Range H&C	Model 9100	N° T.I. 13_2017
Serial Number 74312443	Subject Z4000 ES - FB HOT WATER INLET IMPROVEMENTS

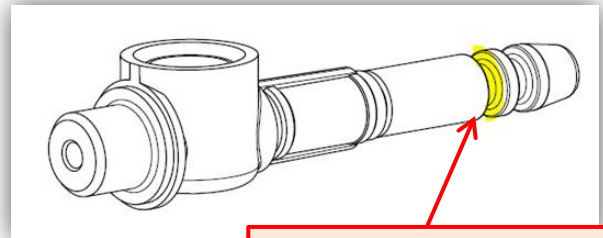
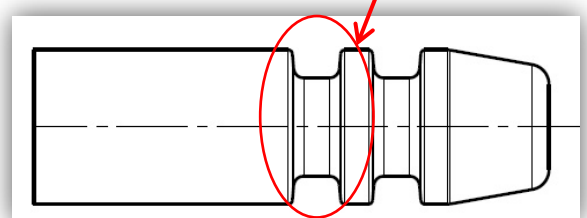
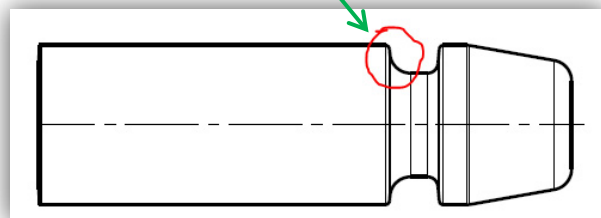
The O-ring seat (marked in yellow colour in the picture below) has been removed, because it is no longer used.

The radius of the gasket seat has been increased: now it smoother then before (see the circle in red).

O-ring seat deleted

Radius of the gasket seat increased

➤ The spare part code is not changed : **260824**

➤ Machines concerned by modification from S/N **74312443**

The **new** solution is retrofittable.
